Beaver Valley Power Station, Unit No. 2
Docket No. 50-412, License No. NPF-73
Response to Request for Additional Information
Regarding Steam Generator Inspection Report (EPID L-2019-LRO-0042)

Response to Request for Additional Information Page 1 of 4

Table 3-6 – Voltage Growth Cumulative Distribution

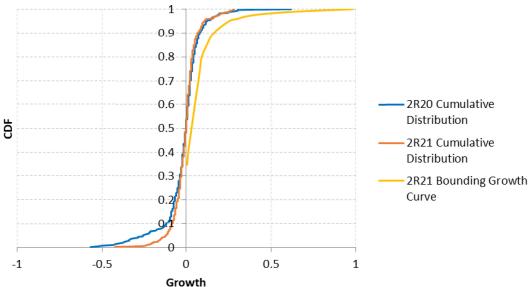
2. Section 3.2, "Voltage Growth Rates," of the GL 95-05 voltage-based ARC report for 2R21 states that "Growth is determined when the same indication can be identified in two successive inspections. Since there can be new indications in one outage, the number of indications for which growth can be defined is less than the number of indications detected." As previously stated, the GL 95-05 voltage-based ARC report for 2R21 reported 407 DSIs in SG-C (this number may change based on Question 1). However, Table 3-6, "Voltage Growth Cumulative Distributions," of the same report shows 409 indications with growth and Table 3-7 shows 364 indications with growth. Please confirm the number of indications with growth for SG-C, the number that was used for the growth analyses, and, if necessary, discuss any impacts this may have had on the results of the growth analyses.

The 409 indications shown in Table 3-6 (Page 3-10) for SG-C was a transcription error. Table 3-6 should have reported 364 indications with growth for SG-C. Table 3-6 is hereby corrected as shown on Page 4 of this response.

The 409 value for number of DSI's with growth in SG-C was a transcription error and was not used in the evaluations for calculating leak rate and probability of burst. The correct growth distribution is shown in Figure 3-7 (Page 5 of this response) and is based on the correct number of DSI's with growth data which for SG-C is 364. Also, as seen from Figure 3-7, a bounding growth curve was used for the evaluations. Therefore, there is no impact on the growth distribution used as input to the 2R21 operational assessment. The incorrect 409 value is not reported elsewhere in the 2R21 GL 95-05 90 Day Report.

Further, the totals for DSI's with growth of 347 in SG-A and 447 in SG-B reported in Table 3-6 are consistent with the findings associated with addressing RAI No. 1 on Page 2 of this response.
